North Eastern Regional Power Committee

Sub: 81वीं संरक्षण समन्वय उप-समिति (पीसीसी) बैठक का कार्यवृत्त/ Minutes of 81st Protection Coordination Sub-Committee (PCC) Meeting

81st Protection Coordination Sub-Committee Meeting

Date: 24/07/2025 (Thursday)

Event 1: At 05:15 Hrs of 21-06-2025

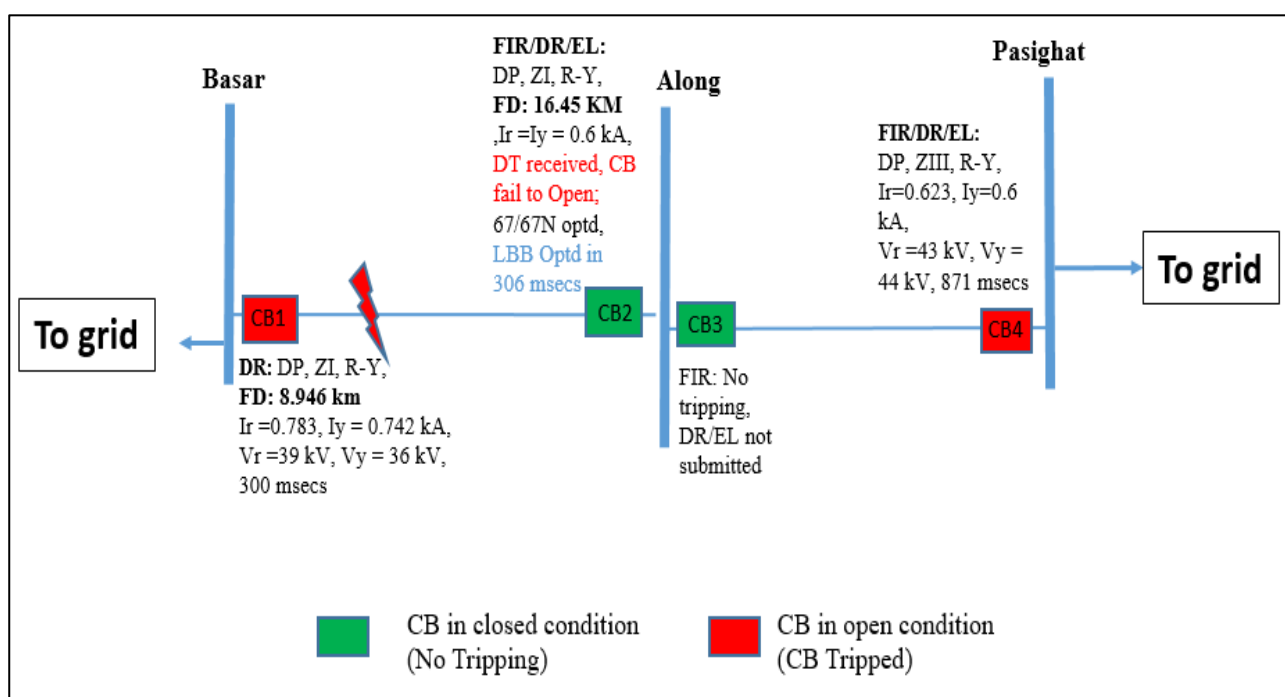
As per DR analysis, resistive R-Y fault ($I_r = 0.783$ kA, $I_y = 0.742$ kA) initiated at 05:14:17.444 Hrs in 132 kV Basar-Along line which was cleared within 300 msec from Basar end on operation of DP, ZI (delayed CB opening). However, CB fails to opens from Along end despite issuance of trip command by distance protection relay in ZI and the fault continued to feed from Roing side till 871 msec. The fault was

- **Delayed operation of CB (CB1) at Basar:** At Basar end, fault initiated at 05:14:17.444 Hrs and ZI trip command issued at 05:14:17.467 Hrs. However, CB opened after 276 msec which is undesirable.
- **Non operation of CB (CB2) at Along:** The distance protection at Along end issued the trip command. However, CB fails to open which is undesirable.
- **LBB protection at Along SS:** DR of 132 kV Basar - Along line at Along showing LBB Operation after 306 msec. However, CB did not open at Along S/S. LBB time delay needs to be reviewed and set as per NERPC protection philosophy.
- **DT received at CB (CB2) at Along:** At 05:10:33.574 Hrs, DT received at Along end. However, no DT sent from the Basar end.
- **DR time drift at Along (CB2):** DR for main relay at Along showing fault initiation time of 05:10:33.523 Hrs which indicates DR time drift of 5 minutes.

Event 2: At 16:52 Hrs of 23-06-2025

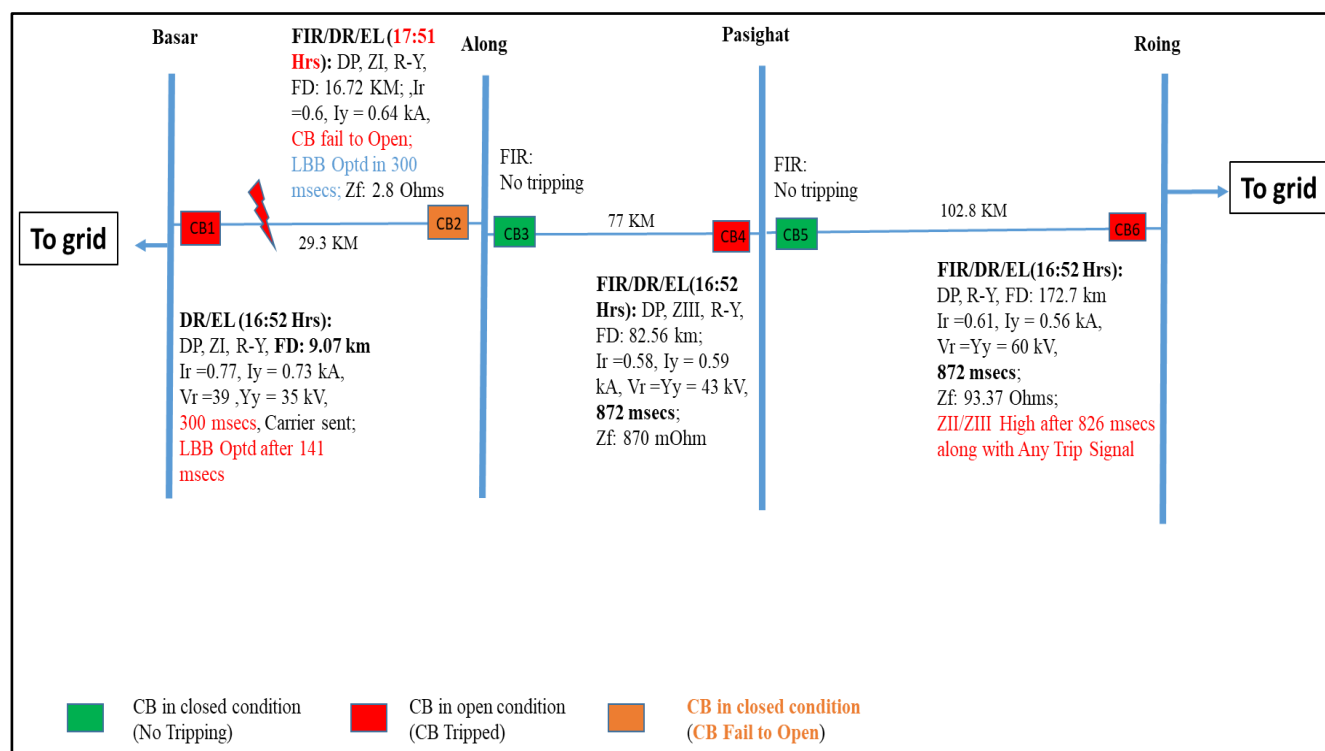
- LBB protection at Along SS:** The Disturbance Recorder of the 132 kV Basar–Along line at Along shows that the LBB operated only after 300 milliseconds, despite a breaker failure (CB2 stuck) condition. DoP, Arunachal is requested to confirm the reason for non-operation LBB at Along SS during the CB stuck condition. Also, make necessary modification/corrective on immediate basis.

5. For Event 2, Regarding zone 3 operation of CB6, PGCIL informed that Zone 3 reach settings were modified earlier but issue persisted. He raised the doubt over correctness of line lengths. He requested DoP Ar. Pradesh to provide the distance of 132 kV Along -Pashighat line so that zone 3 reach can be correctly modified. POWERGRID informed that Offline fault locator of 132 kV Roing-Pasighat line to be carried out to ascertain the exact line length.

B.18 Grid Disturbance in Lumshnong & Amrit areas of Meghalaya Power System on 25th June'25:

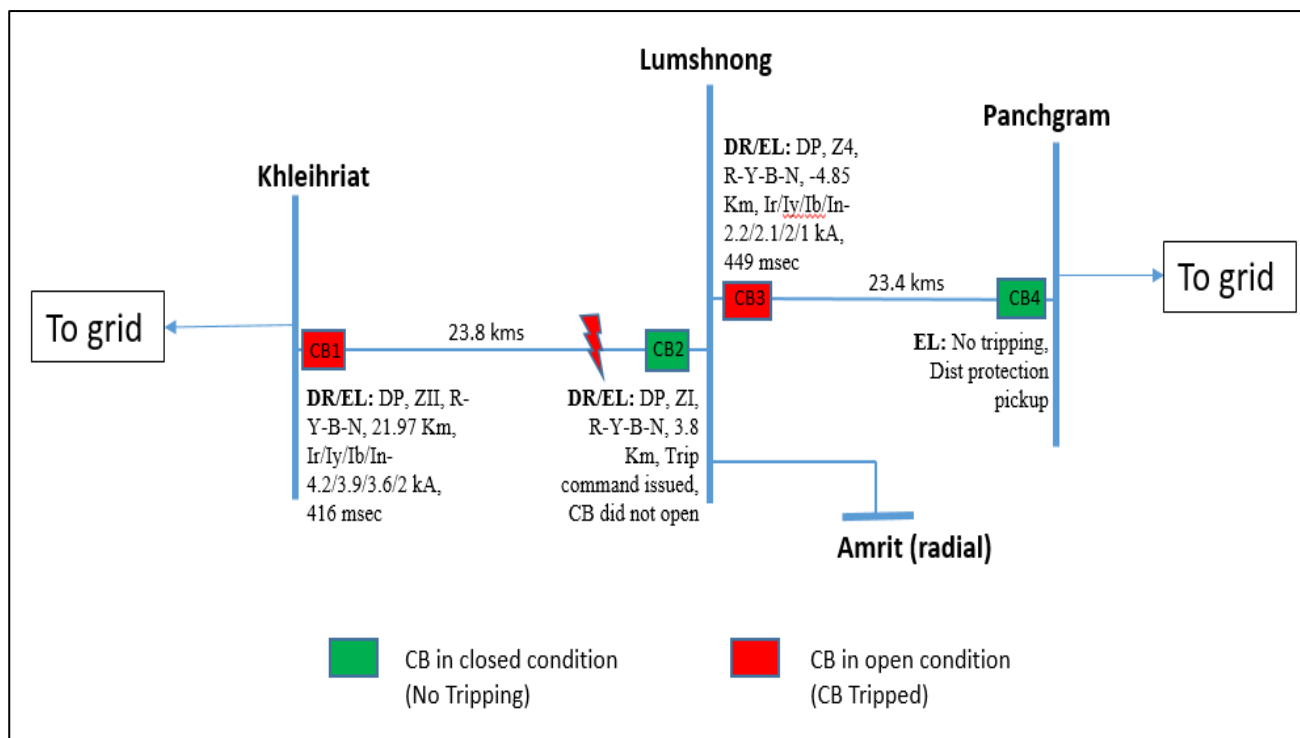
As per DR analysis, R-Y-B-N fault (Ir-4.2 kA, Iy-3.9 kA, Ib-3.66 kA, In-2 kA) initiated at 23:24:29.571 Hrs in 132 kV Khliehriat-Lumshnong line which was cleared within 416 msec from Khliehriat end on operation of DP, ZII. From Lumshnong end, ZI trip command issued 23:23:42.094 Hrs. However, CB did not open. As a result of which fault was continuously feeding from Panchgram end.

B.19 Grid Disturbance in Rokhia area of Tripura Power System on 28th June'25:

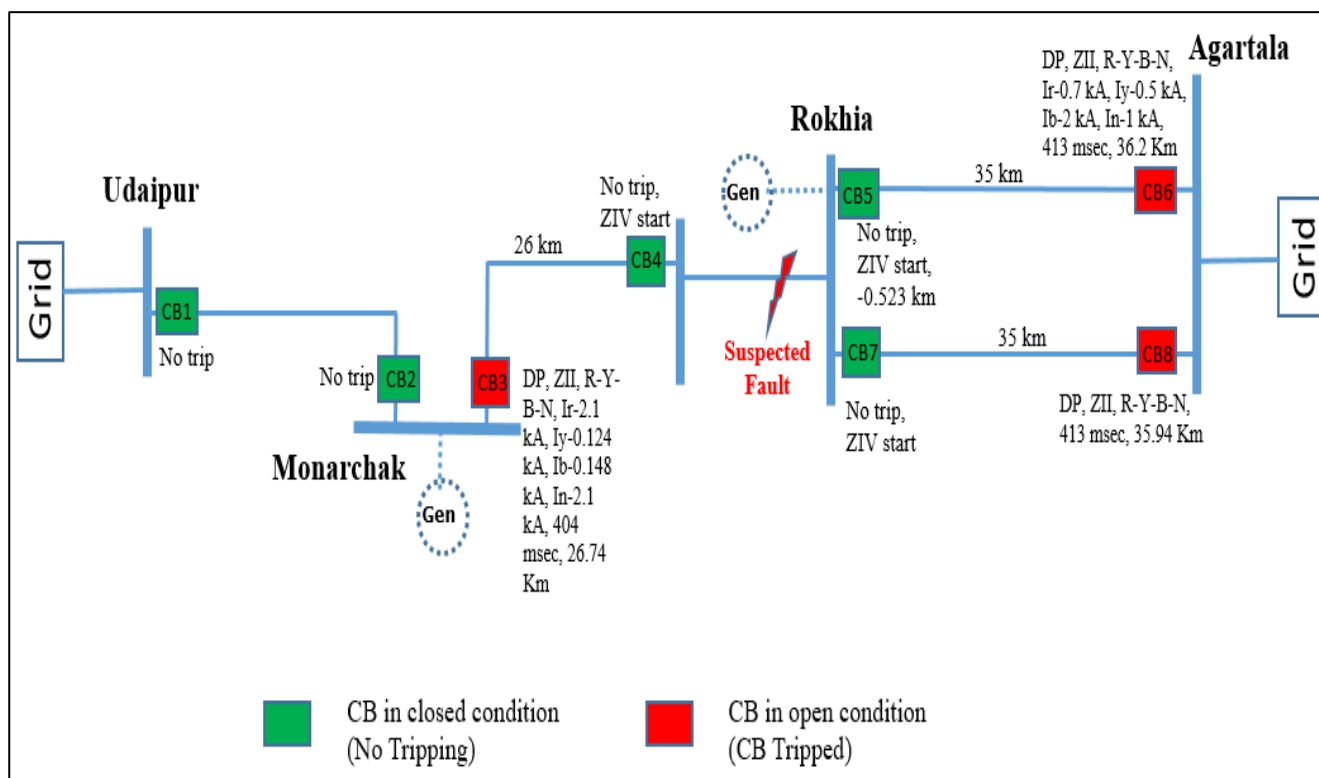
Suspected R-Y-B-N fault of solid nature in Rokhia S/S or 132 kV Old Rokhia-New Rokhia Link feeder which was cleared by tripping of all the healthy lines connected to Rokhia S/S from remote ends on operation of DP, ZII.

B.20 Grid Disturbance in Amguri (Jackson) area of Assam Power System area of Assam Power System on 26-06-2025:

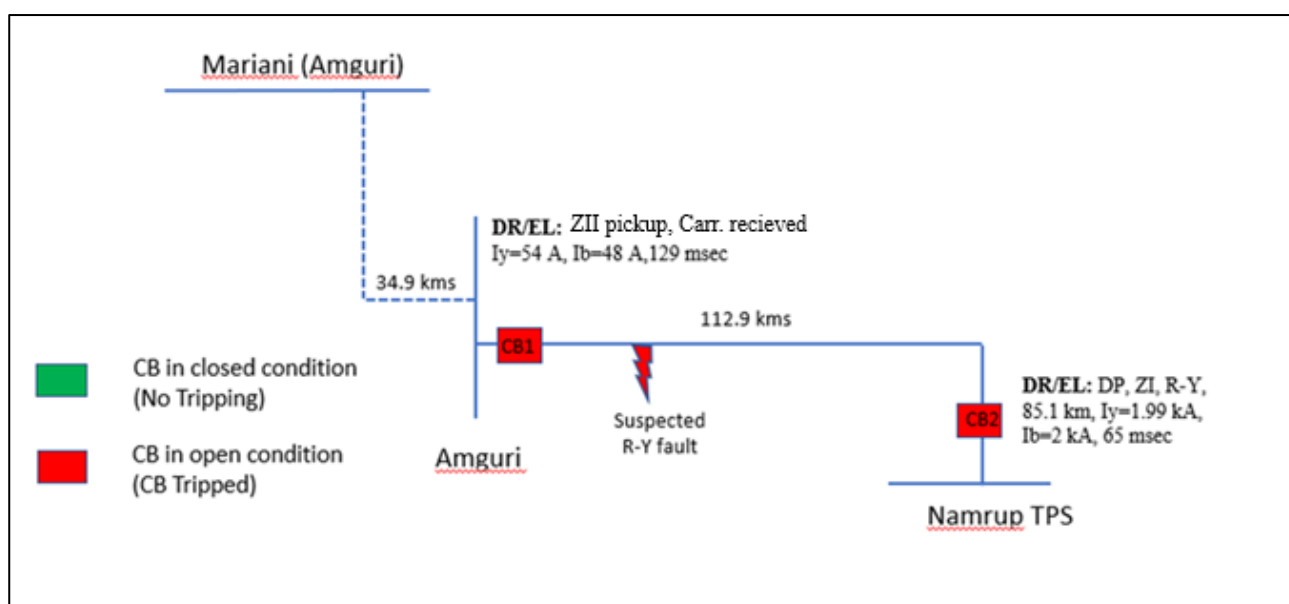
As per DR analysis, Y-B fault (I_y - 1.99 kA, I_b - 2 kA) initiated at 15:19:29.0520 Hrs which was cleared within 65 msec from Namrup TSS end. From Amguri end, Carrier/ DT received (I_y - 54 A, I_b - 48 A).

C.2 Grid Disturbance in Along area of Arunachal Pradesh Power system on 15-05-2025:

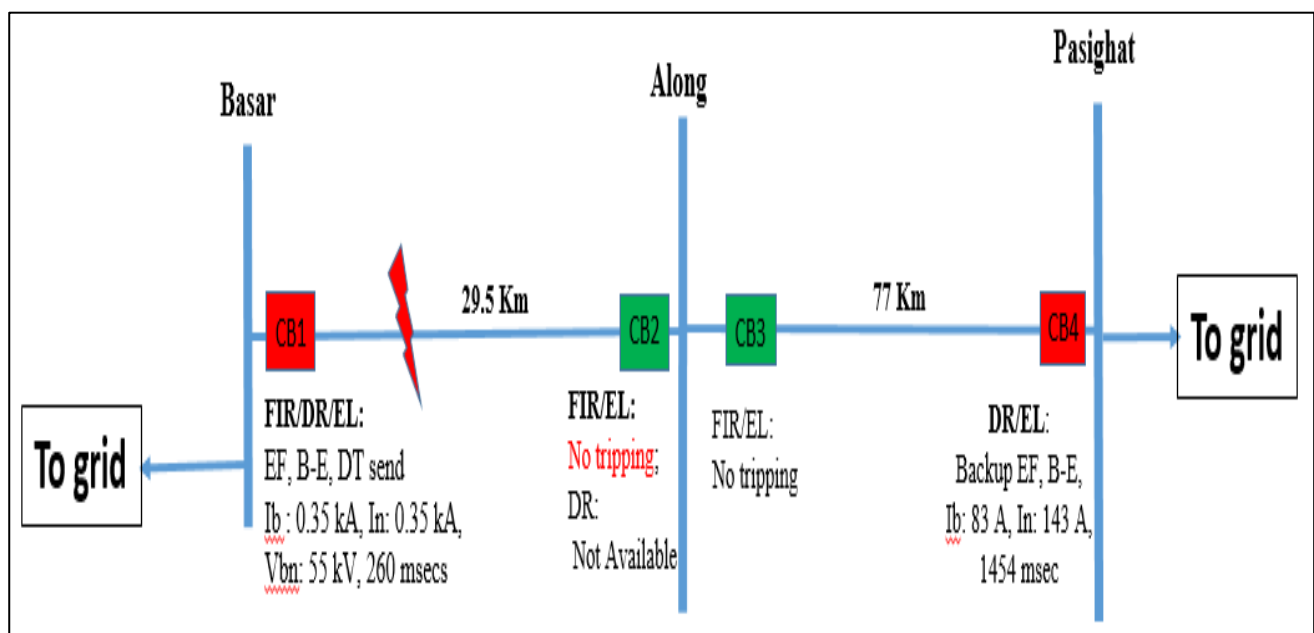
As per DR/EL analysis, high resistive B-N fault (Ib- 325 A, In-325 A) initiated at 04:31:35.760 Hrs in 132 kV Along-Basar line which was cleared within 260 msec from Basar end on operation of E/F protection (DT send). There was no tripping from Along end due to which fault was continuously feeding from Pasighat end of 132 kV Along line which was cleared within 1.45 sec on operation of B/U E/F from Pasighat end (IN>2 trip observed at 04:31:22.552 hrs)

Event 1: At 06:42 Hrs of 29.05.2025

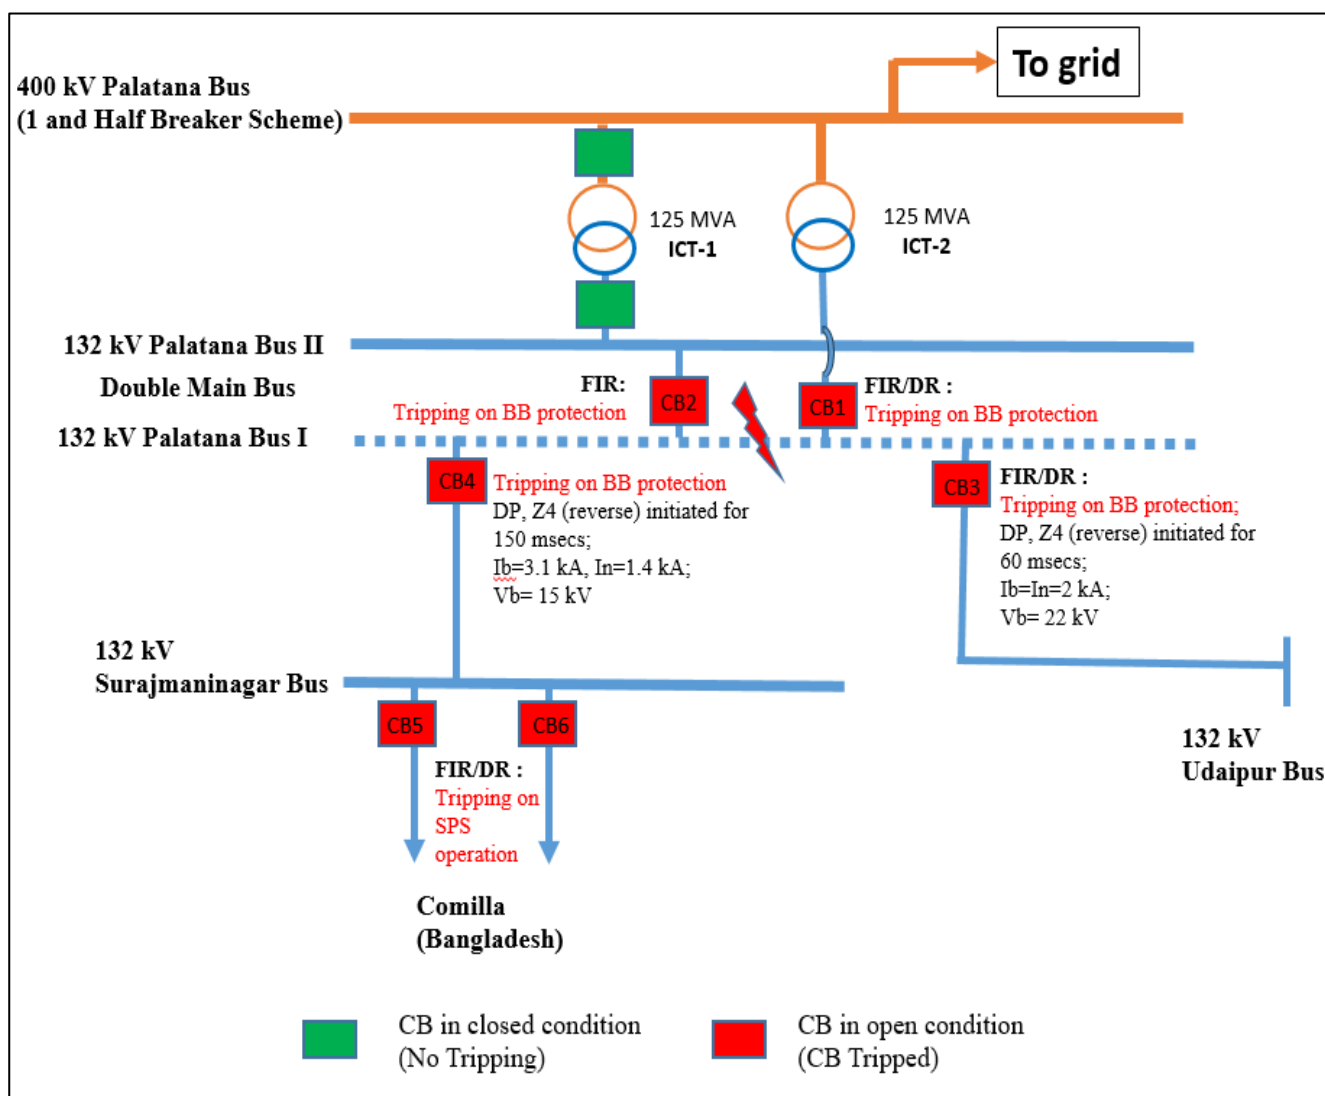
As per DR analysis, B-N fault of metallic nature initiated likely in the 132 kV Surajmaninagar Bus I which was cleared on operation Bus bar protection of 132 kV Main Bus I in 70-80 msec.

The same fault was detected by the main protection of 132 kV Palatana – Surajmaninagar line & 132 kV Palatana – Udaipur line in ZIV i.e. reverse direction. DR time drift of 1 Hr observed at Palatana end for Surajmaninagar line & 8 min for Udaipur line.

Event 2: At 13:08 Hrs of 29.05.2025

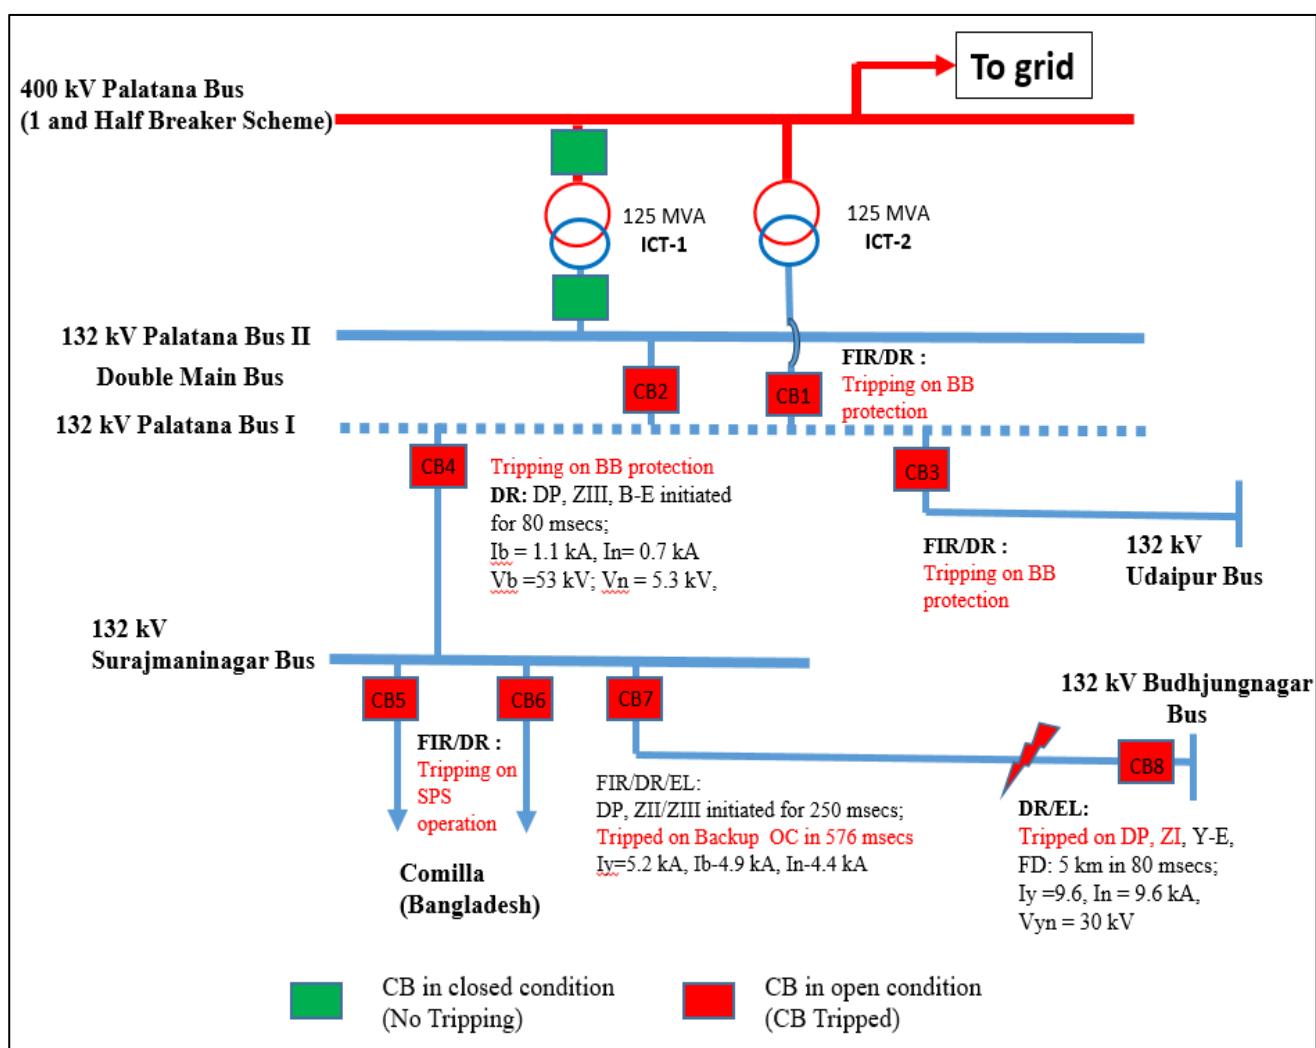
As per DR analysis, Y-N fault of metallic nature initiated at 13:08:01.059 Hrs in 132 kV Surajmaninagar – Budhjungnagar line which was cleared from Budhjangnagar in 80 msecs on DP, ZI & Surajmaninagar in 576 msecs on operation of B/U O/C protection (ZII/ZIII started and deactivated after 250 msec)

OTPC & TSECL may update share the root cause and provide update on the above mentioned issues.

Event 1: Grid disturbance in Chiephebozou area of Nagaland on 22-05-2025

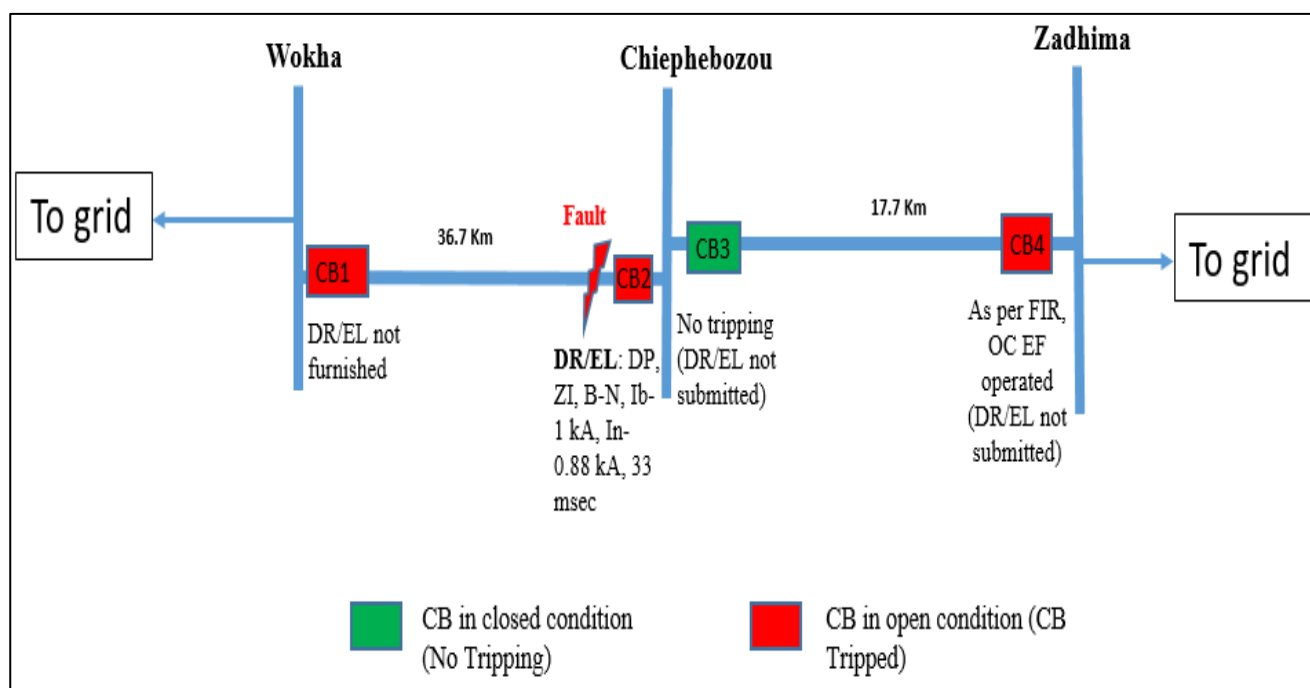
As per DR analysis of 132 kV Wokha-Chiephebozou line, solid B-N fault (Ib-1 kA, In-0.88 kA) initiated at 16:09:08.490 Hrs and cleared within 33 msec from Chiephebozou end on operation of DP, ZI. As per FIR, OC EF operated at Zadhima end for 132 kV Chiephebozou line.

DoP Nagaland may share the root cause of the event and provide update on the above-mentioned issues.
